Subject: MHI's Response to US-APWR DCD RAI No. 350-2675 REVISION 1

**US-APWR Design Certification
Mitsubishi Heavy Industries
Docket No. 52-021**

RAI NO.: NO. 350-2675 REVISION 1
SRP SECTION: 05.02.03 - REACTOR COOLANT PRESSURE BOUNDARY MATERIALS
APPLICATION SECTION: DCD TIER 2, SECTION 5.2.3
DATE OF RAI ISSUE: 5/04/2009

QUESTION NO.: 05.02.03-17

Fig.1 pH range at 25°C

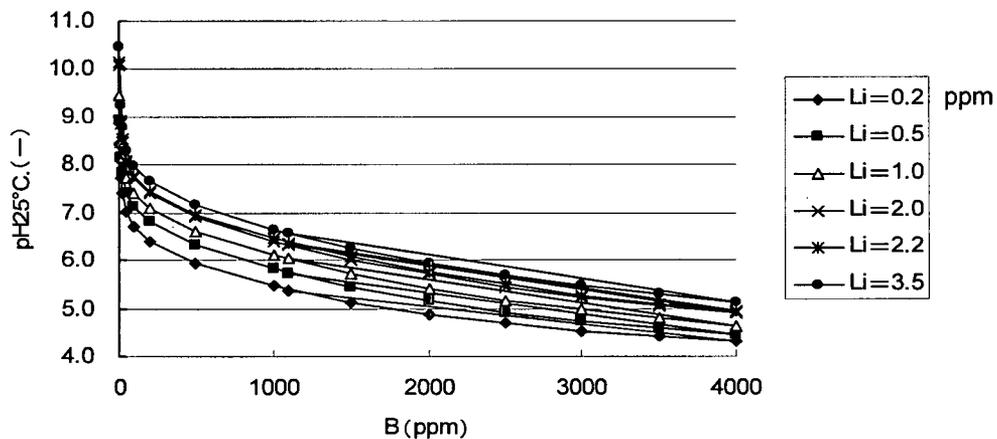
1. Clarify whether the pH limits given in Table 5.2.3-2 are intended to cover all operating modes (e.g., refueling, cold shutdown, startup, shutdown, and power operation), and when it would be necessary to allow a pH as high as 10.5? Is this a limit to prevent materials damage or representative of an actual plant operating condition?
2. Describe the strategy for pH control for the entire operating cycles, including startup and full-power operation. Discuss any plans to vary pH over the course of the fuel cycle. Is the intent for the US-APWR to follow a modified chemistry regime as defined in the EPRI Guidelines?

Recommended pH range of Reactor Coolant Water Chemistry is described in Table-5.2.3-2 in the DCD. These values are pH at 25°C water chemistry condition.

Basically, pH of Reactor Coolant Water Chemistry is determined by boric acid and lithium concentration. Value of pH 4.2 (at 25°C) corresponds to combination of boron concentration 4000ppm and Li concentration 0.2ppm. Furthermore, pH 10.5 (at 25°C) corresponds to combination of boron concentration almost 0ppm and Li concentration 3.5ppm.

Fig.3 Change of pH at 25°C

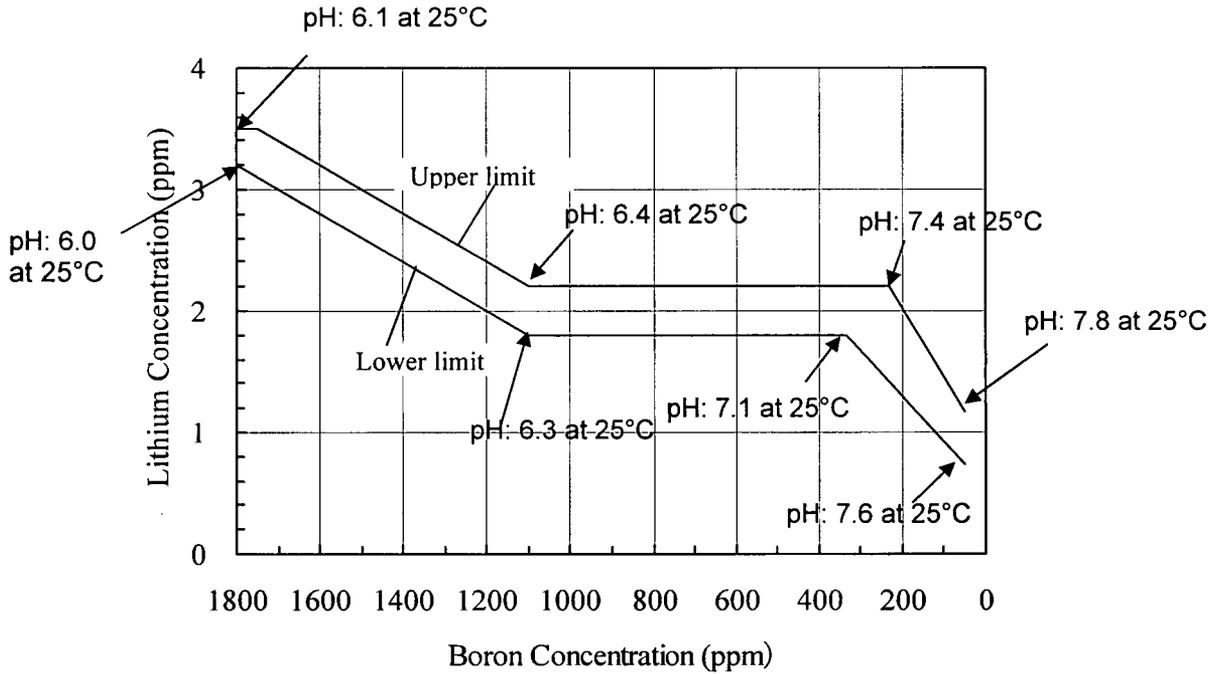
Additionally, in the RAI response, the applicant added temperature and pH labels to the upper- and lower-limit lines in Fig. 5.2.3-1. However, the explanation of pH control in the text is inconsistent with the figure. DCD Figure 5.2.3-1 resembles Figures 2-4 and A-2 of the EPRI PWR Primary Water Chemistry Guidelines, Rev. 6 (EPRI guidelines). The supporting discussion and the pH labels on Figure 5.2.3-1 leave the impression that the Upper Limit and Lower Limit curves (each consist of 3 connected segments) are curves of constant pH. This is not the case, as can be seen from EPRI Guidelines Figs. 2-2, 2-5, and Table A-3, where curves of constant pH are monotone decreasing. The middle region of constant lithium inventory (seen in both EPRI Guidelines Fig. 2-4 and DCD Fig. 5.2.3-1) is actually one of changing pH (increasing as boron decreases). (There is also such a flat region in EPRI Fig. 2-3.) The EPRI Guidelines describe different strategies of varying lithium and boron additions during startup and operation, and some of these strategies involve deliberate changes in pH over the course of operation (this is certainly

According to lithium control band during power operation in Figure-5.2.3-1 in the DCD, ranges of pH at 25°C (without impurity) are shown in Fig. 3. Value of pH is within 4.2 -10.5.

Fig.4 Change of pH at 300 and 285°C

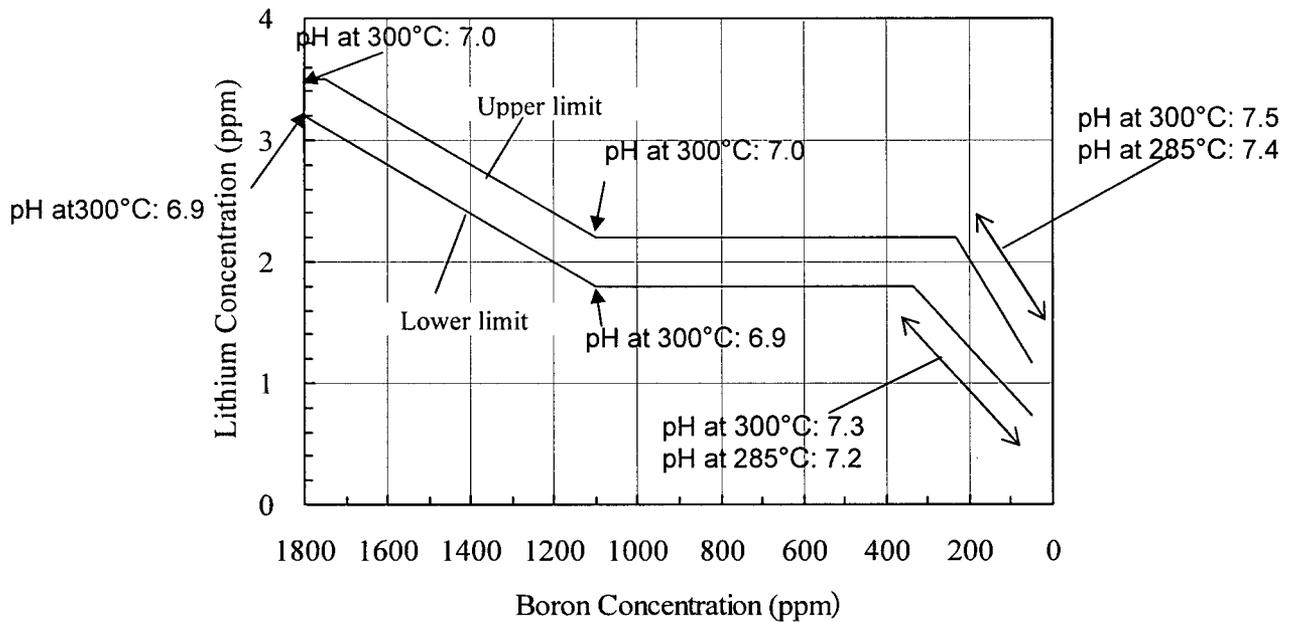
true of the "modified" approach represented by Fig. 2-4). The DCD describes a plan of maintaining constant pH within limits, and does not mention any change in the limits over an operating cycle. Thus, the DCD text is inconsistent with both DCD Figure 5.2.3-1 and Figure 2-4 of the EPRI Guidelines, which both depict a modified chemistry regime in which the pH changes during the course of the cycle. The staff desires that applicant provide more detail regarding their approach to pH control. Simply referencing the "EPRI Model" is inadequate, since the EPRI guidelines does not clearly define a model, and mentions several that are in use.

Values of pH in several points are shown in Figure 4 below. In USA, high temperature pH is calculated under 300°C. Therefore, MHI calculates pH at 300°C. When boron concentration decreases from 1800 to 1100 ppm, pH is kept constant around 7.0. When boron concentration decreases from 1100 to almost 300 ppm, pH increases. When boron concentration decreases from almost 300 to 50ppm, pH is kept around 7.4 ± 0.1 .

Optimum high pH value range at 300°C, shown in Fig. 4, is 6.9 to 7.5. In constant pH region where boron concentration less than 300ppm, pH value at 285°C is kept 7.3 ± 0.1 . These values are consistent with DCD chapter 9.

MHI will revise Figure-5.2.3-1 in the DCD like Fig.4.
